October 4, 2024
Jeremiah Fettig
City of Aurora
Planning Department

Re: Third Submission Review – DA 2170-07 – Stafford Logistics Center Commercial – Master Plan Amendment, Infrastructure Site Plan, and Plat.
Application Number: DA-2170-07
Case Numbers: 2024-3001-00; 2019-7001-04; 2024-6002-00

PLANNING DEPARTMENT COMMENTS

SHEET
TAB 8
Sheet 1 of 1

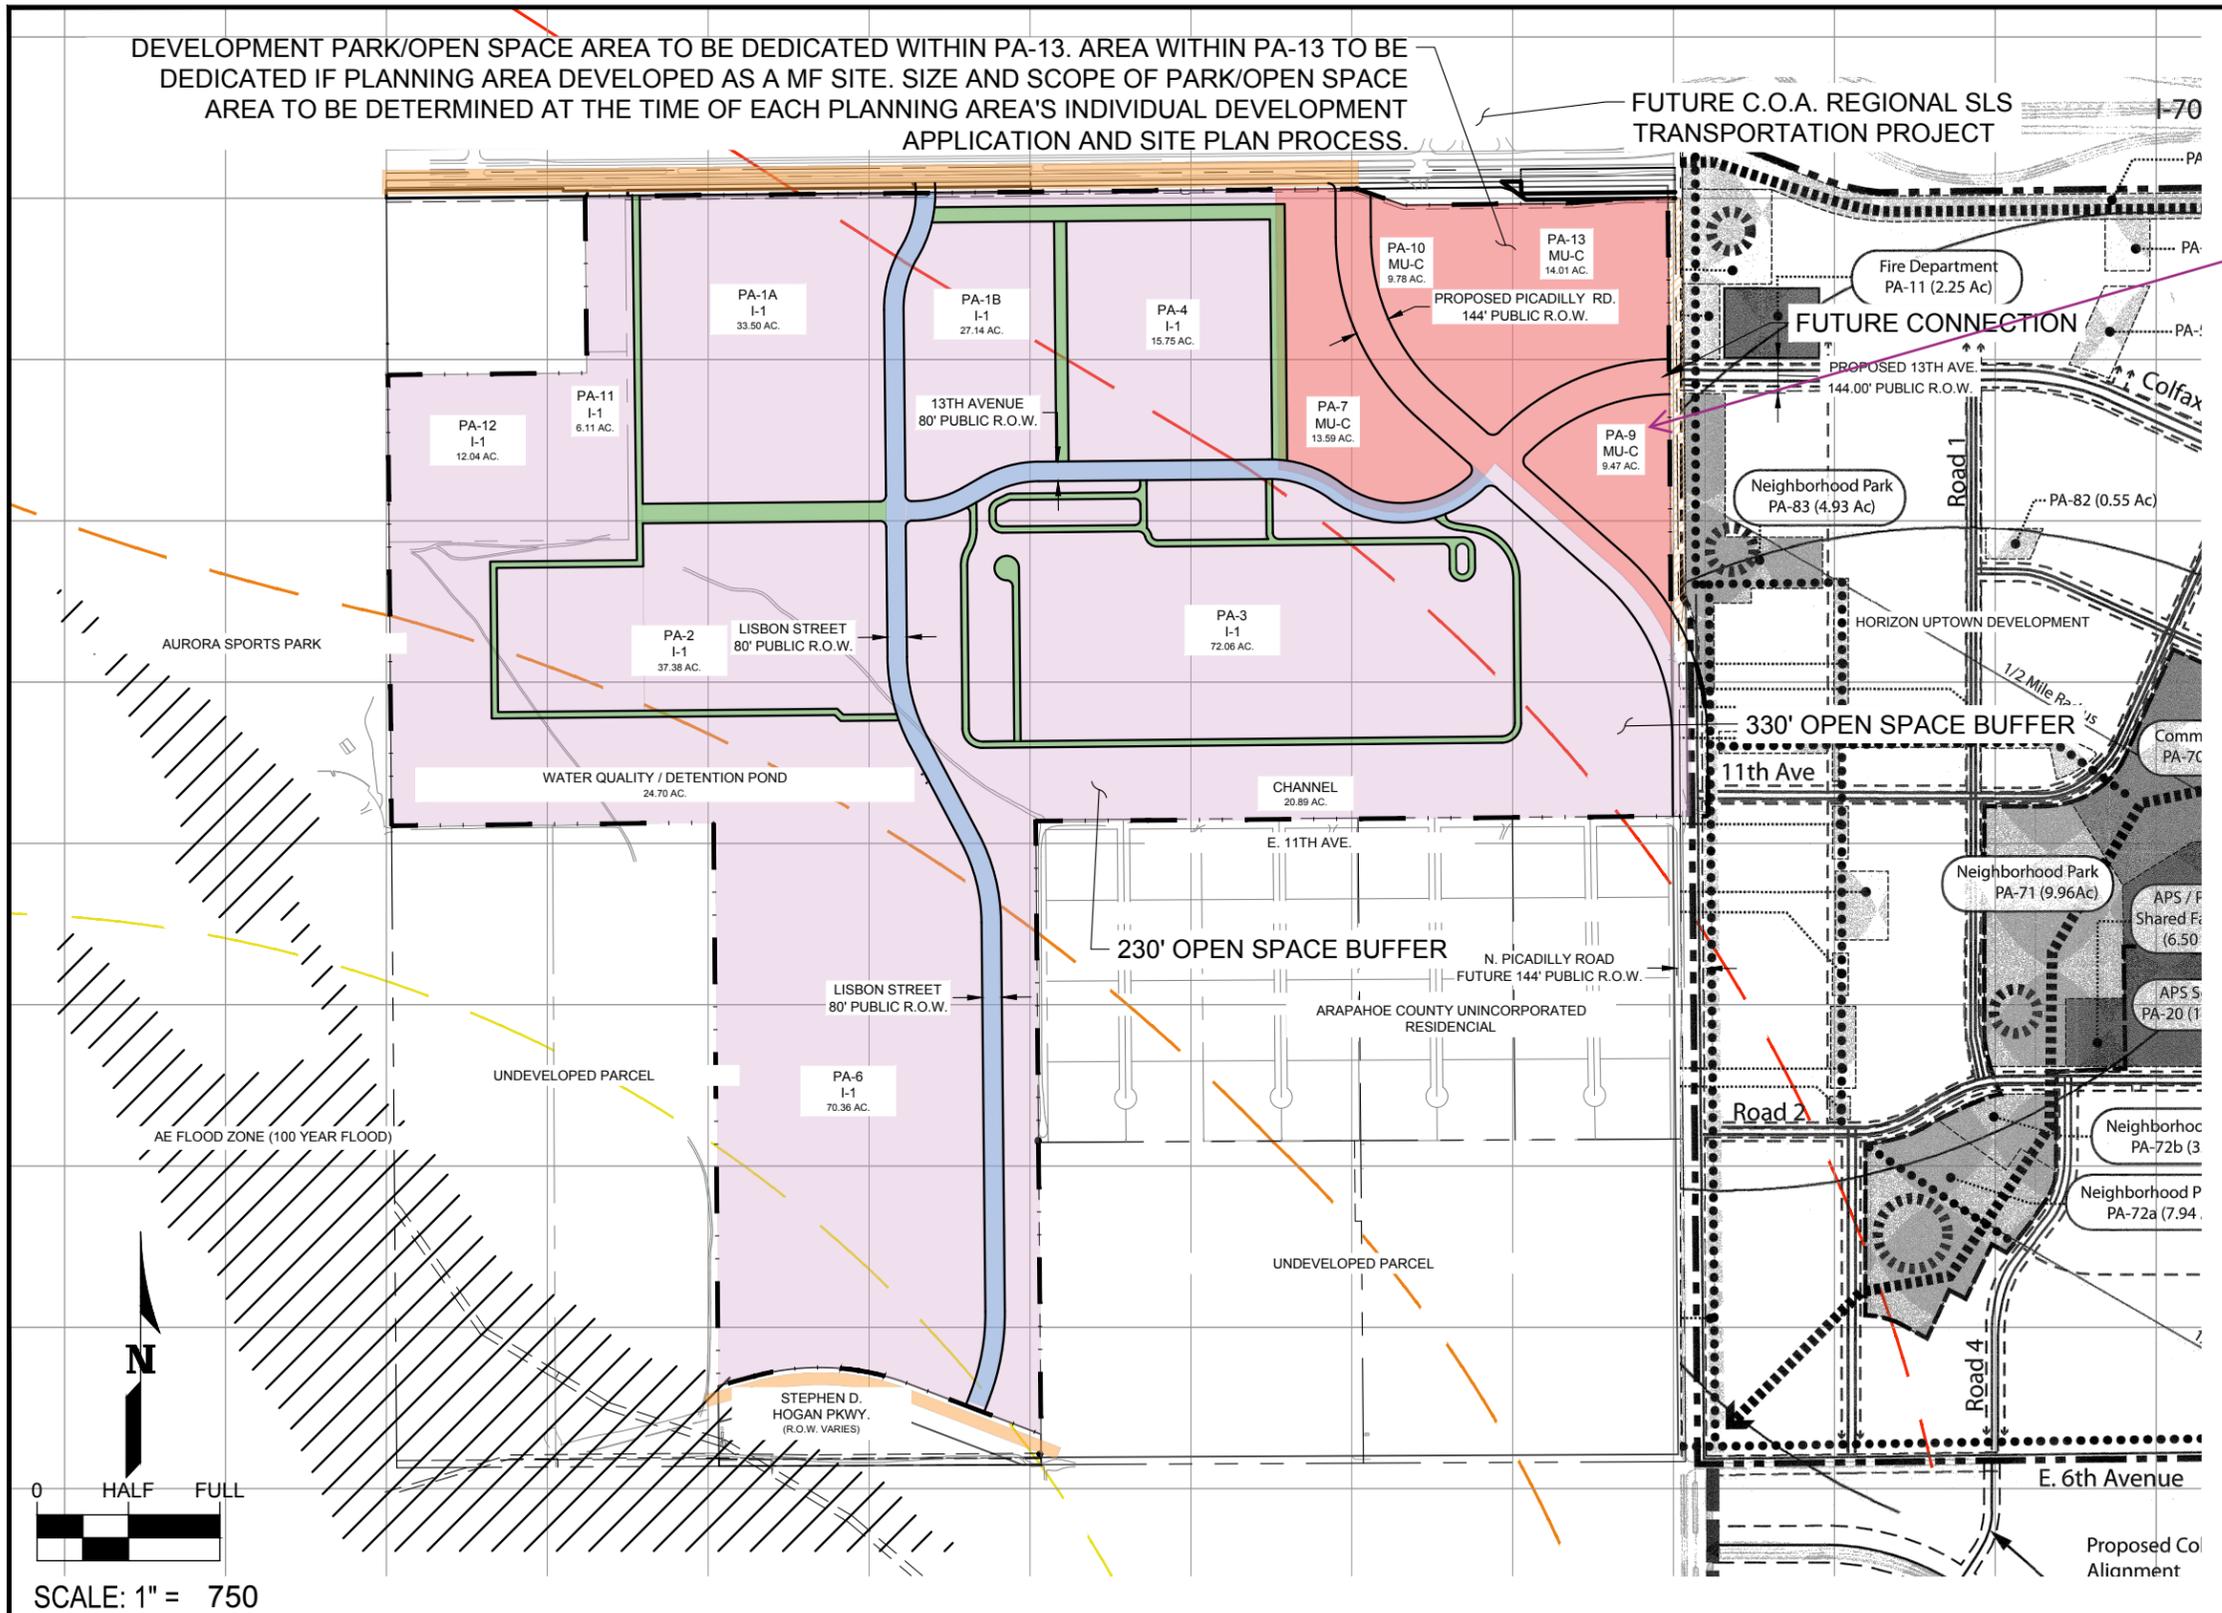
Tab 9 calls out this area as a potential MF site. If this is the case, then include PA-9 in this text at the top stating that PA-9 parkland will be required on-site as well.

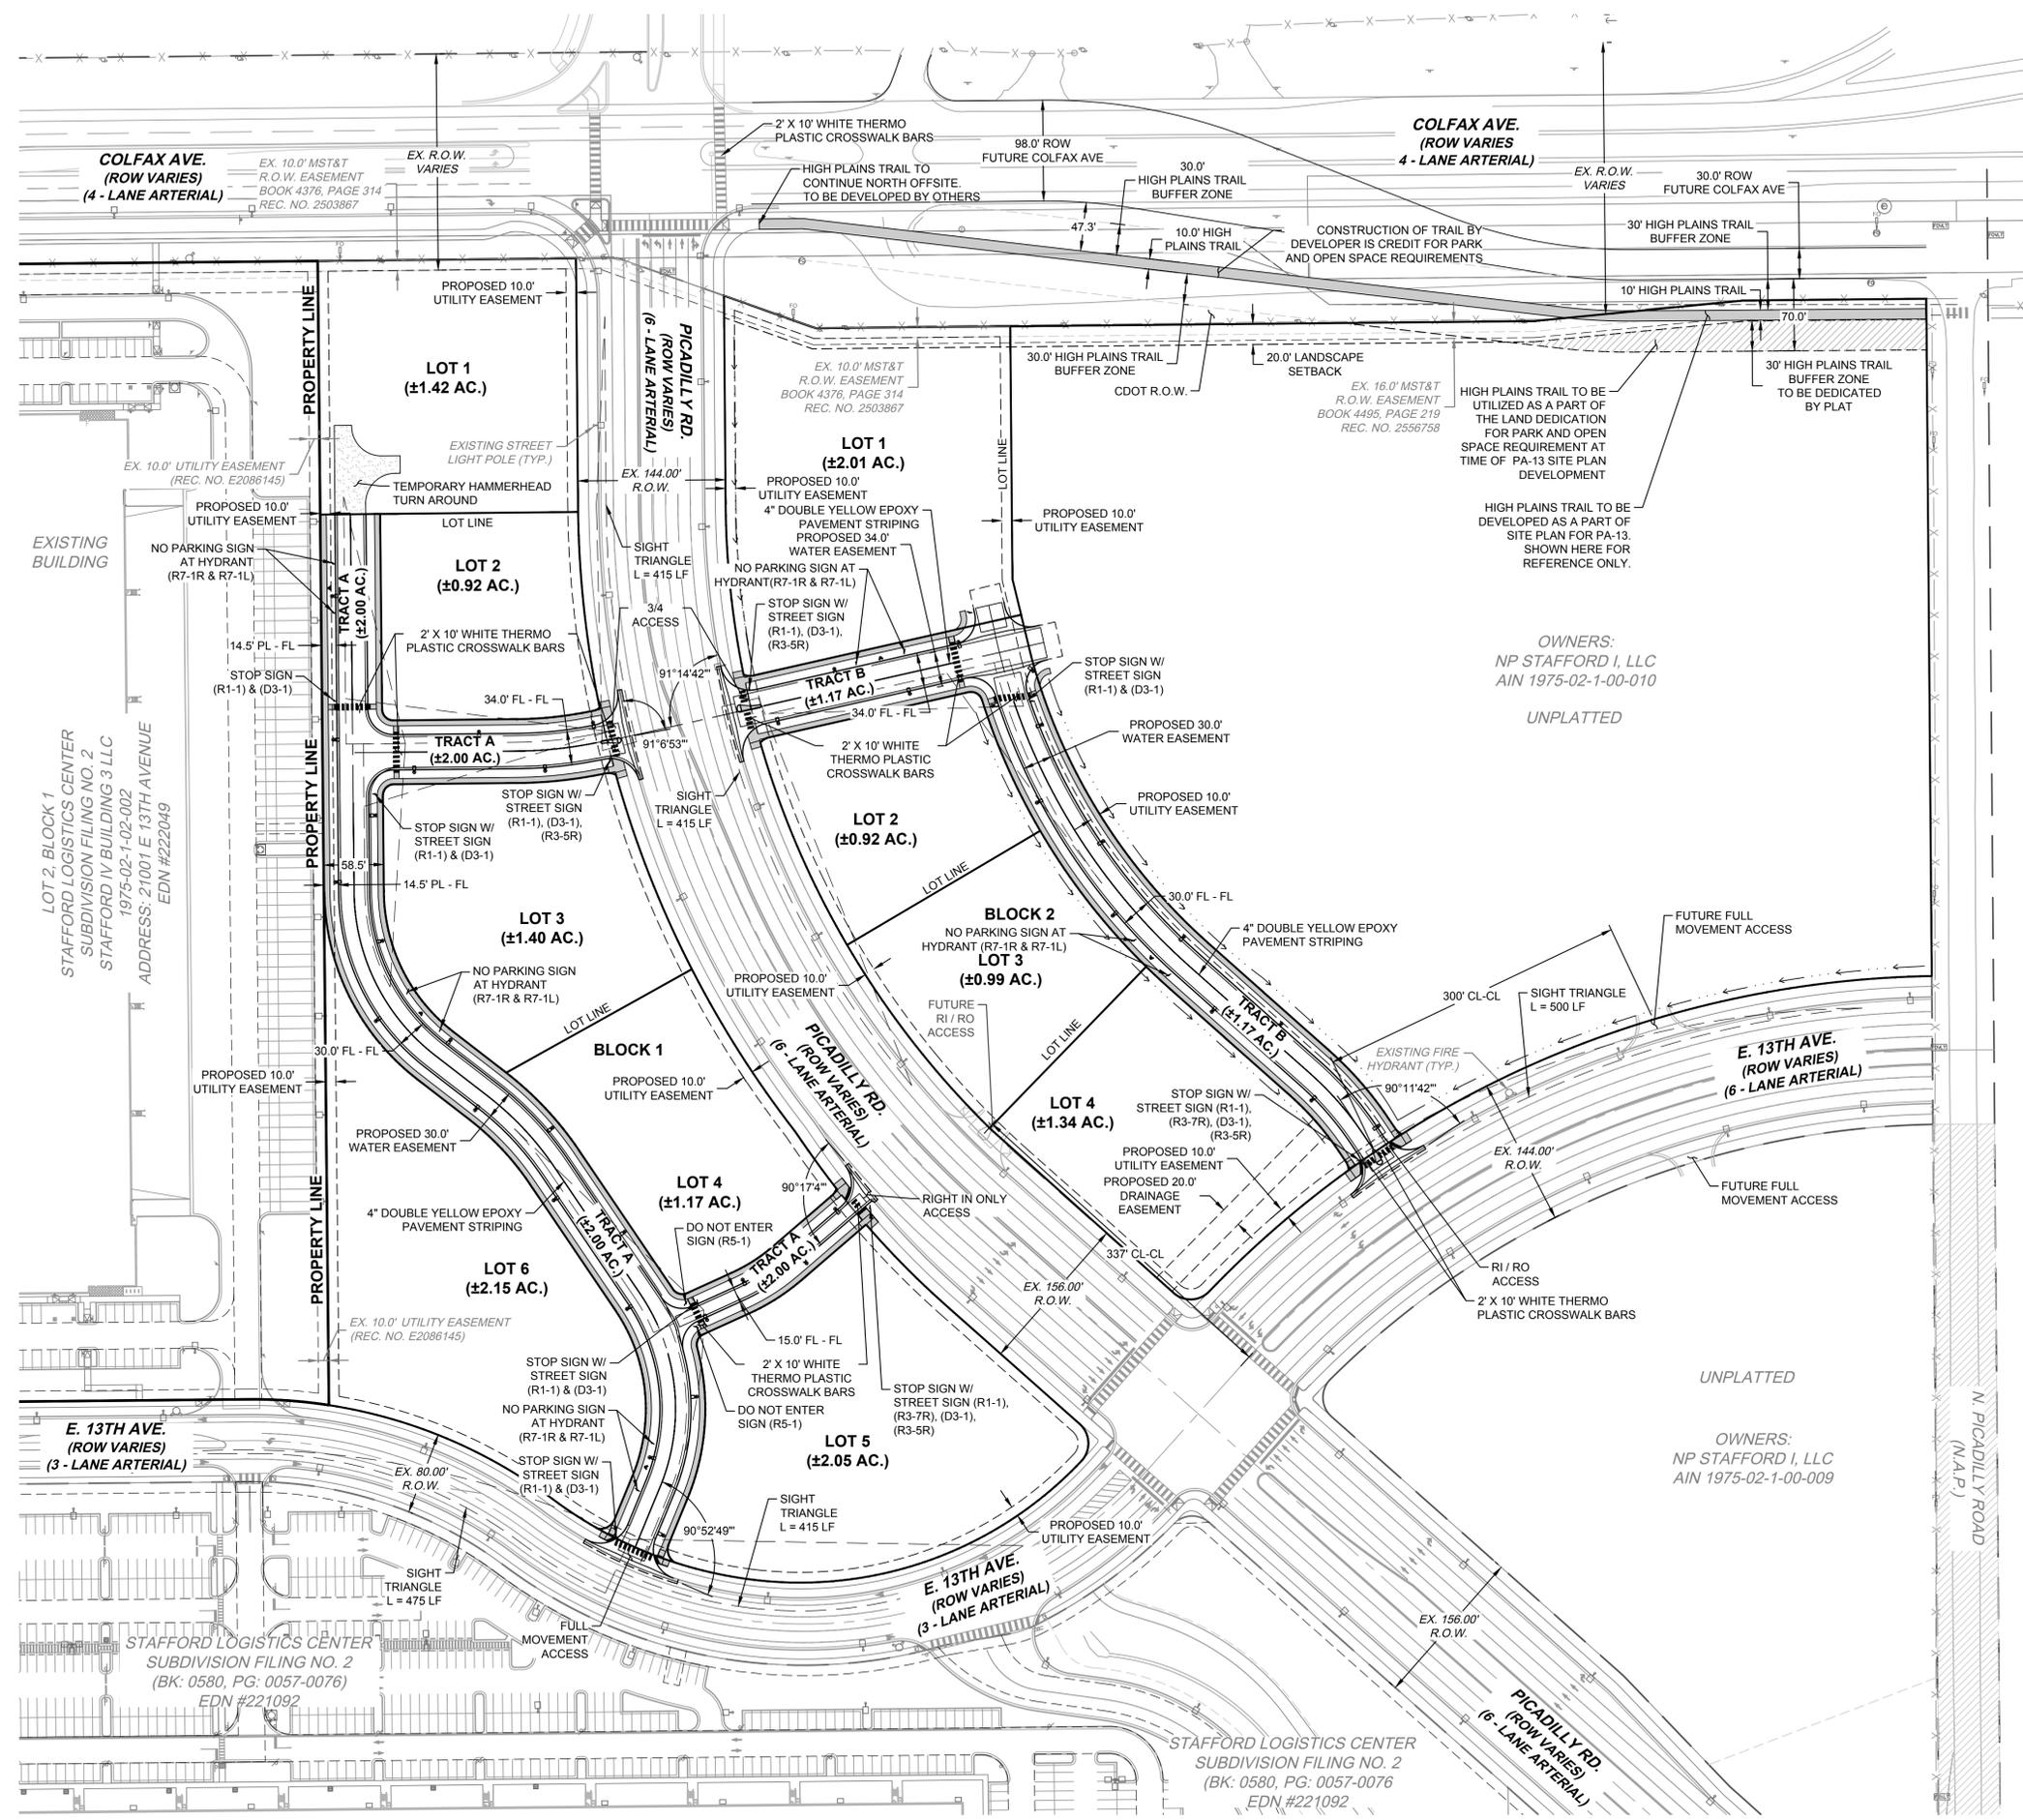
Merge this cell with the two cells to the right and insert the following text: Density will be limited to the ability of the planning area to meet PROS Parkland Dedication and Open Space Requirements on-site.

Cells merged and note added. Thank you.

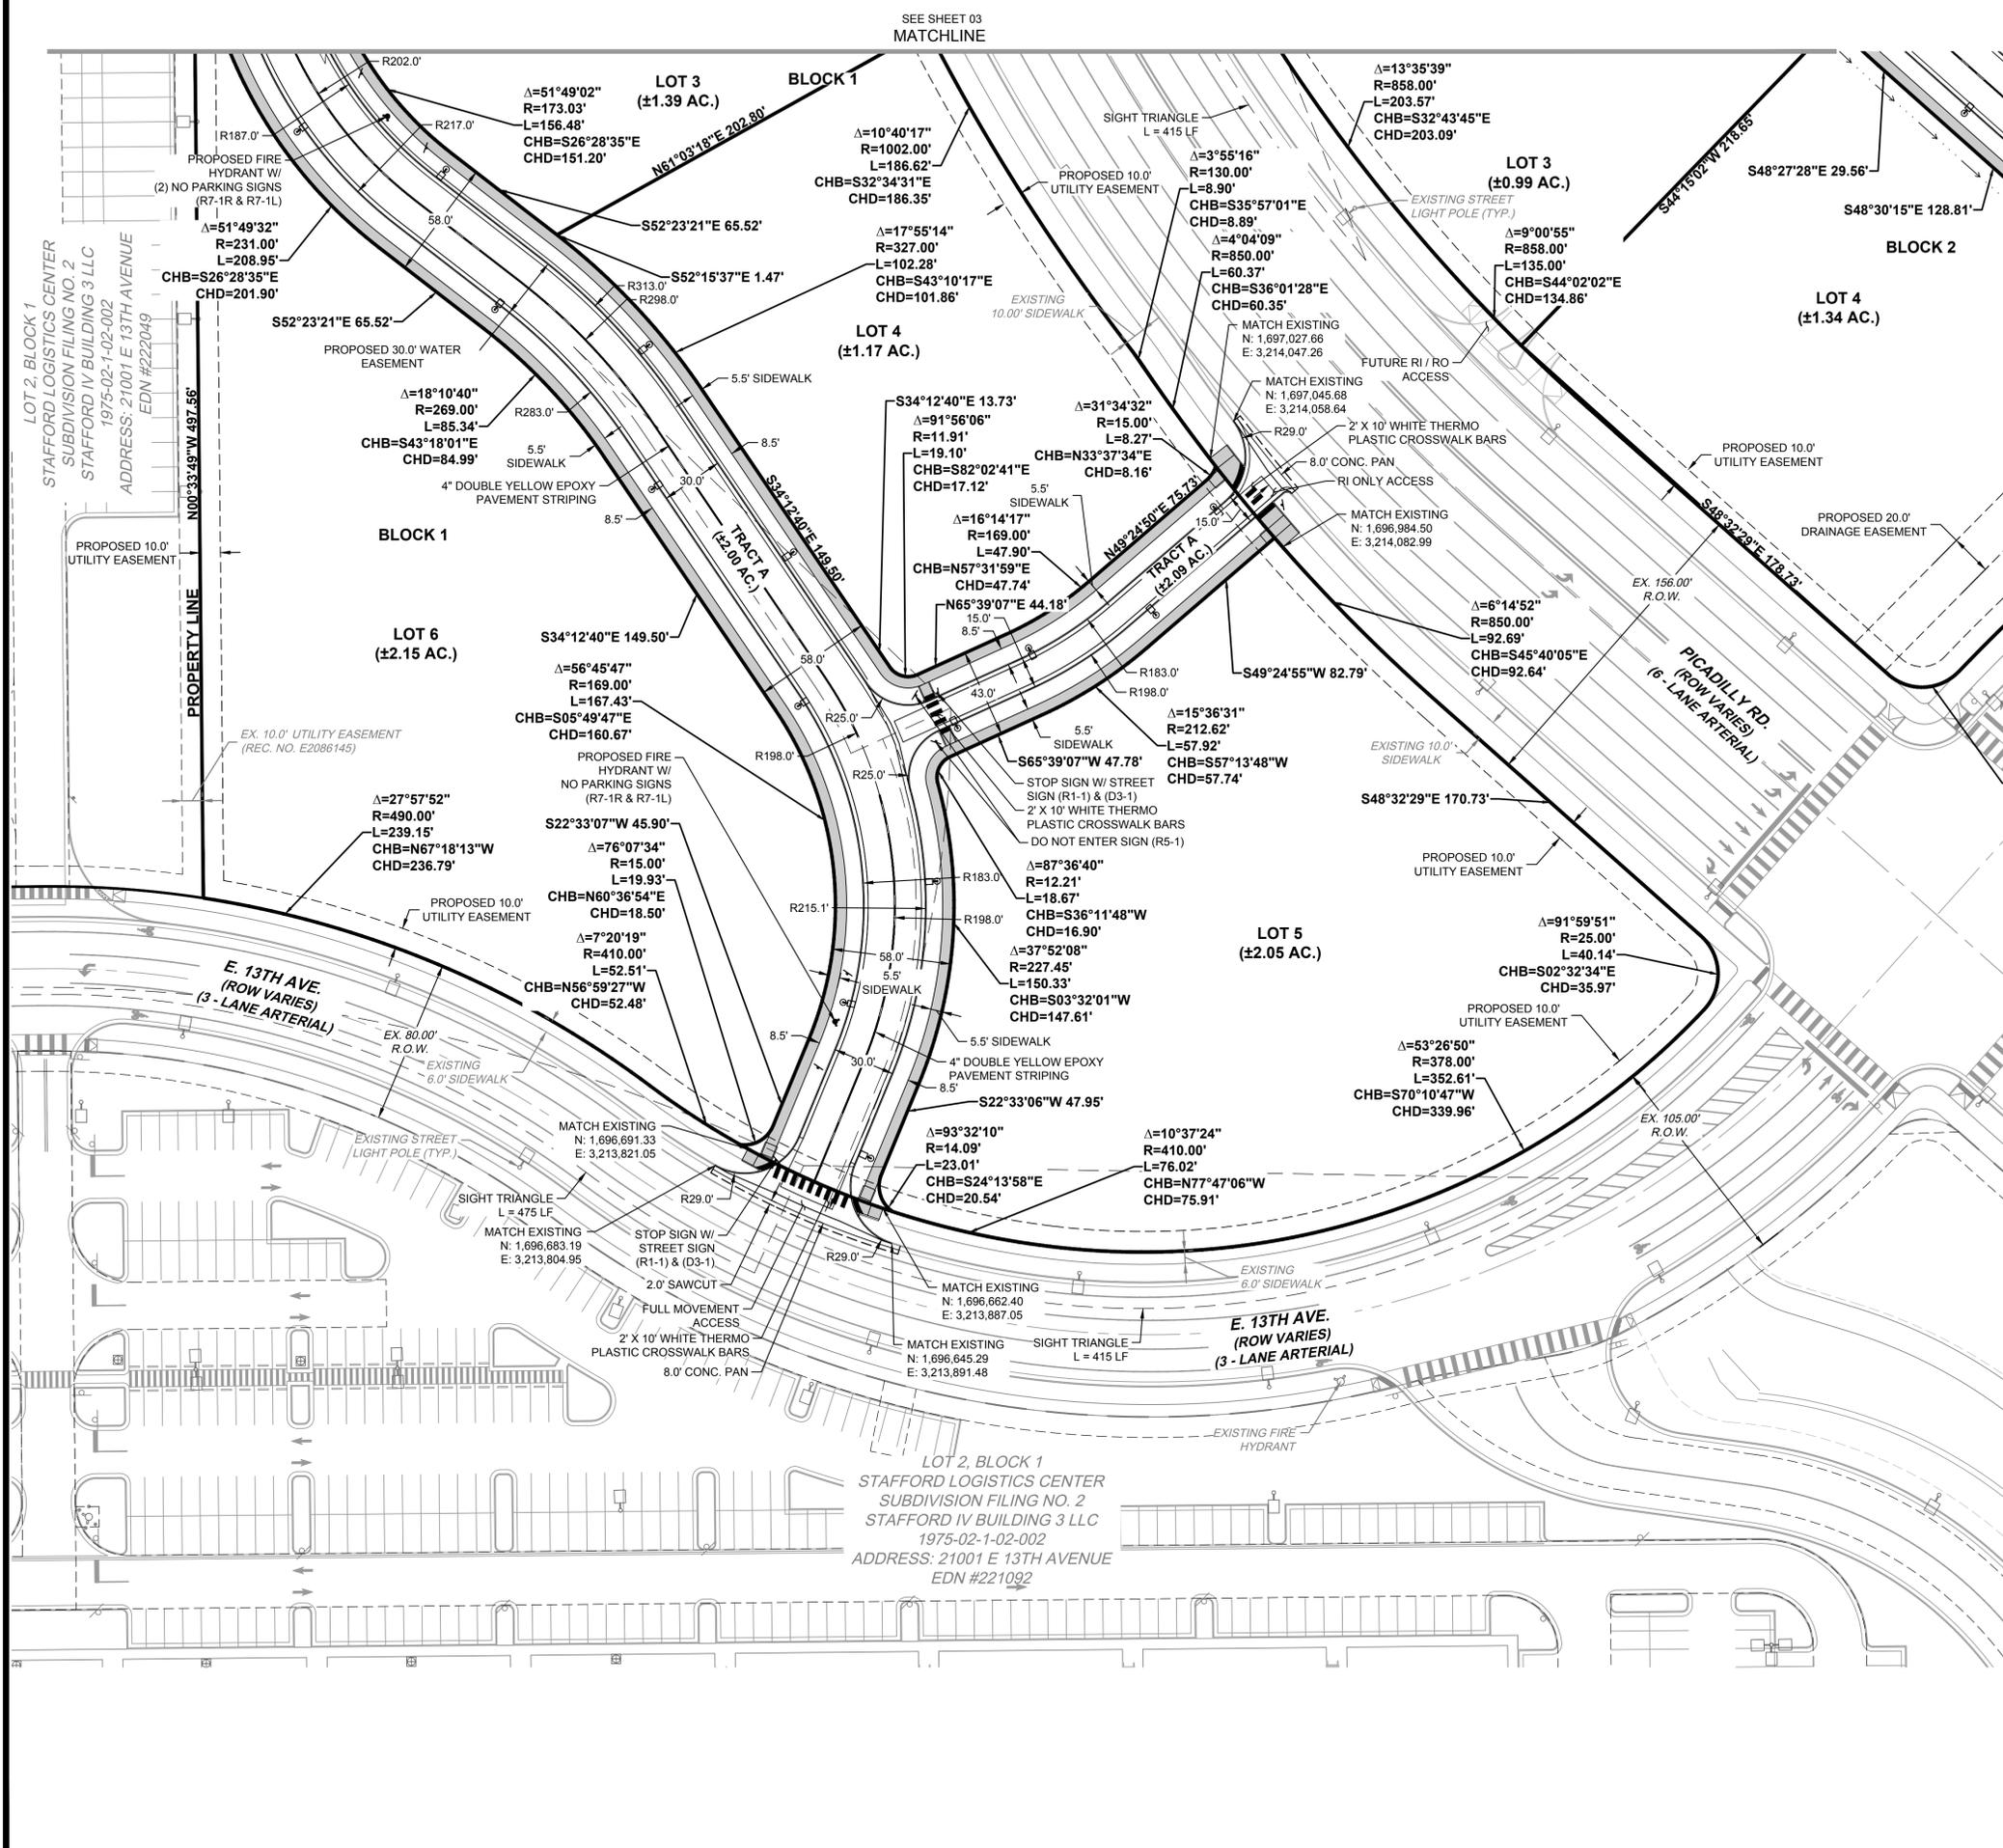
text overlap

text overlap has been removed.
